HUSEMAN WANG, INC.
Consulting Engineers

ST. MARY MAGDALEN SCHOOL
B BUILDING BATHROOM RENOVATIONS AND ADDITIONS
ERROL BARRON/MICHAEL TOUPS ARCHITECTS

REV. MAY 2 97
04/16/97
M-0

MECH EQUIP. SCHEDULE

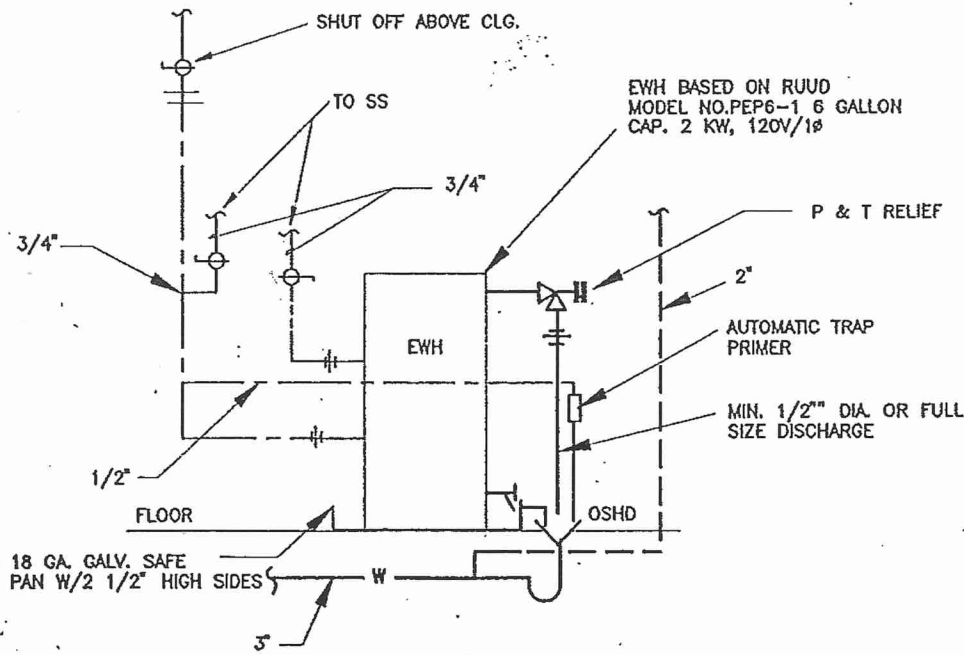
WALL HUNG TOILETS

CHANGE MFG'S. →

MODIFY →

CHANGE MFG'S. →

- TRANSFER GRILLE: TITUS 355FL 18X14 SURFACE MOUNT, ALUMINUM FINISH MOUNT ABOVE DOORWAY. FIRE DAMPER; RUSKIN 1BDT2 18X14 THIN LINE FIRE DAMPER
 - EF-1,2,3,4: EACH EXHAUST FAN TO BE GREENHECK SDE-12-24-E. MOUNT EACH FAN IN WALL MOUNT COLLAR. PROVIDE BACKDRAFT DAMPER, GREENHECK SPEED CONTROL SWITCH, AND RUSKIN ELFB11DD 18X18 LOUVER FOR EACH. 600 CFM, 0.1" E.S.P. 120V/1Ø, 1/20 HP.
 - H-1,2,3,4: EACH HEATER TO BE REZTOR 60VC14. 120V/1Ø, 1/10 HP FAN. 2.5 GPM.
 - EWH-1: 6 GALLON, 2 KW ELECTRIC HOT WATER HEATER IN THE JANITOR'S CLOSET. WALL MOUNTED.
- ADD. ALT. #1
REPLACE FLOOR MOUNTED WATER CLOSETS WITH WALL MOUNTED WATER CLOSETS WITH CARRIERS. SUBMIT RISER DIAGRAM FOR APPROVAL.
